Project: Merthyr Synagogue
Job No: 9684
Subject: Comments on further investigations
Made by: JB
Date: 20/02/24
Ref: 9684_SK10
Rev: A

8.3.1 Existing Steps at the Rear - Options Assessment

Project No: **Merthyr Synagogue**
Potential Approaches to Rear Area
Project: **9684**Engineer: **Joshua Bird**Date of Issue: **15/01/2024**Revision: **A**

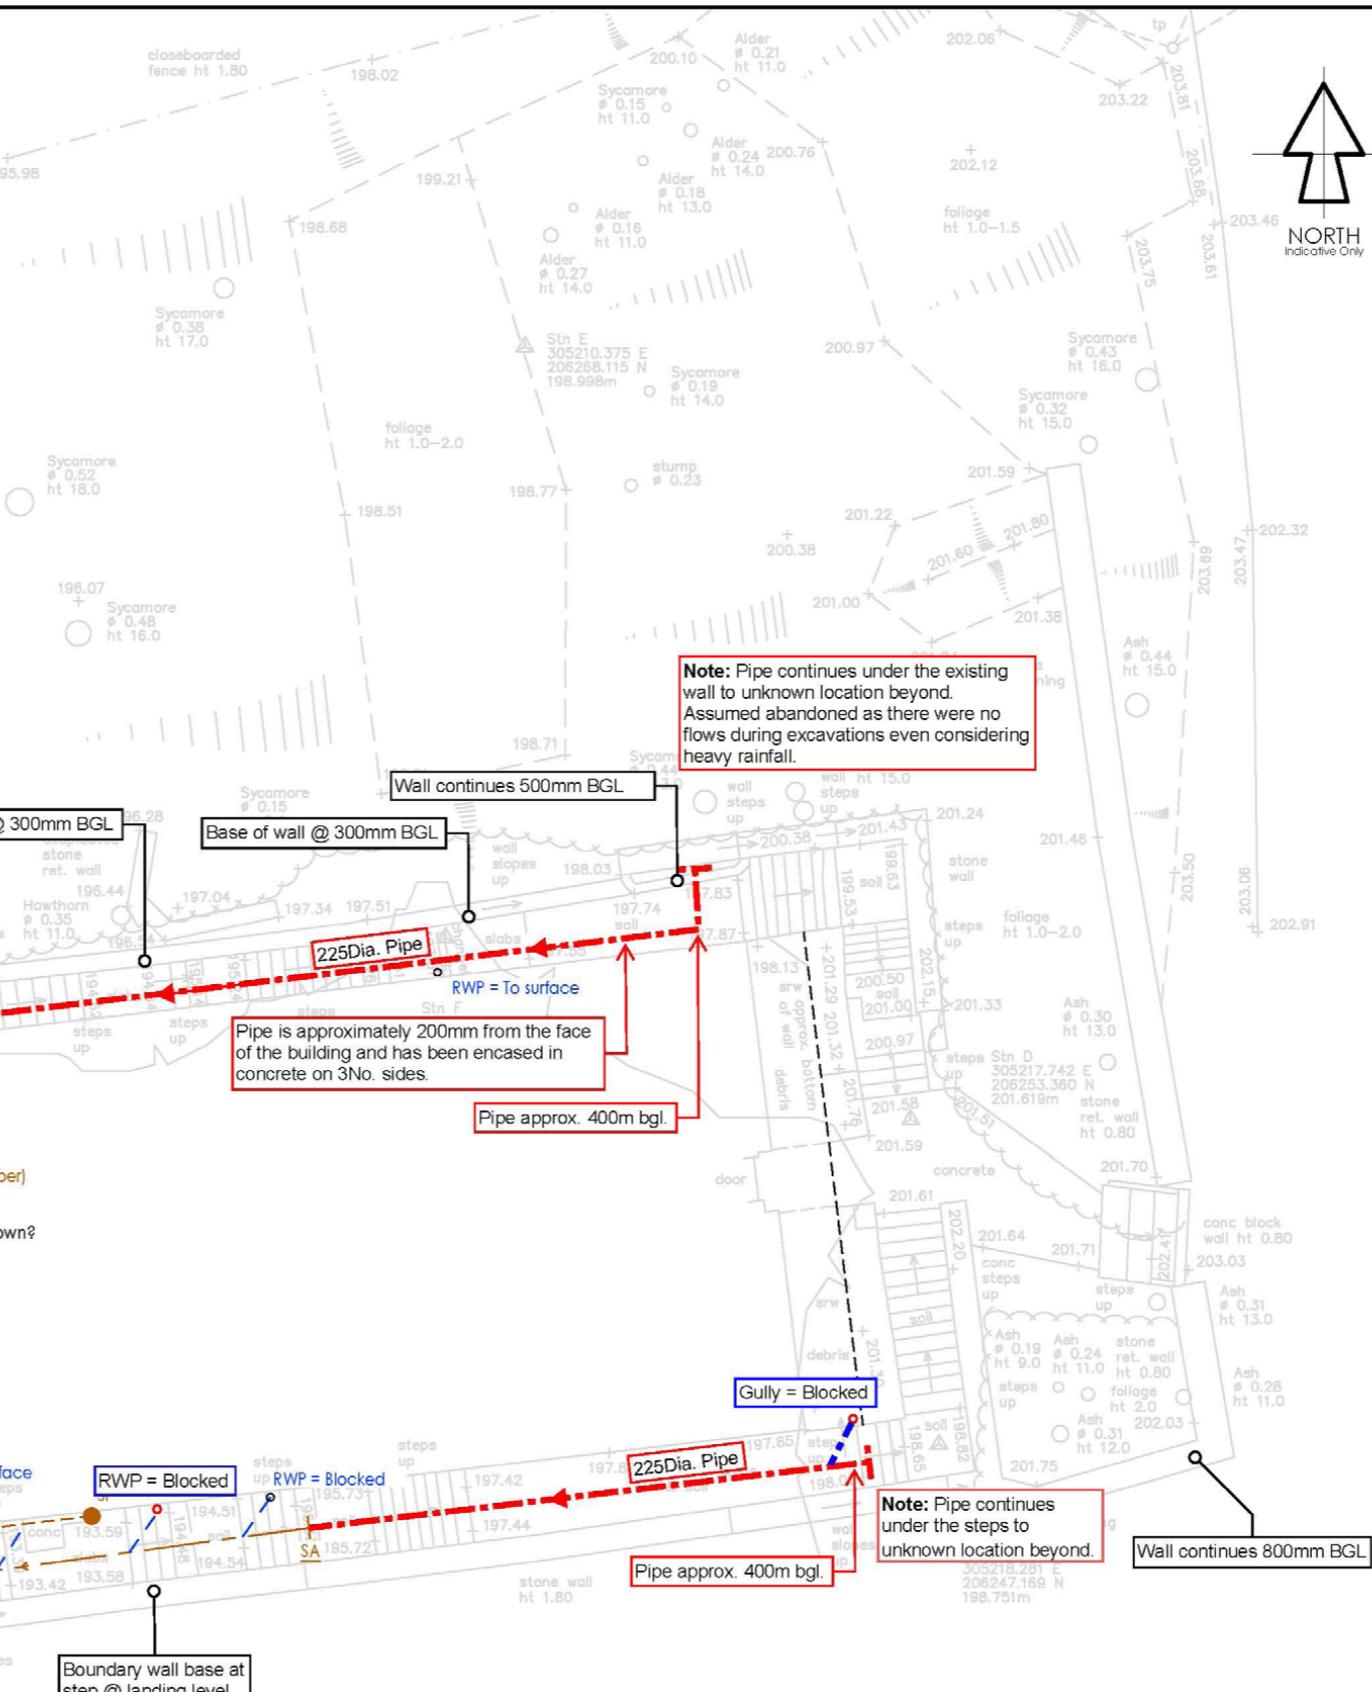
Boundary walls - Apart from 1NO. location on the north wall, we anticipate all walls to be either built up from the step level or have a single course below the steps. Therefore considerations need to be made for how the steps are rebuilt. Following discussions with the Architect a like for like repair is likely to be proposed.

This would likely comprise a step by step repair undertaken from the bottom of the flight to the top. Potential for change of material for treads to be reviewed by Mann Williams in coordination with Architect.

Drainage - As part of the inspections we undertook a quick exercise to try and establish whether the drains still run. This was done by pouring water into holes created in the upper ends of the pipe (on the upper landing) and inspecting whether flow was visible at the bottom.

The North pipe is notably flowing well however there was some evidence of silts within the pipe which may have restricted the flow.

The South pipe flows however at a noticeably slower rate therefore we suspect there may be some localised trapped materials / vegetation which may be restricting the flow.
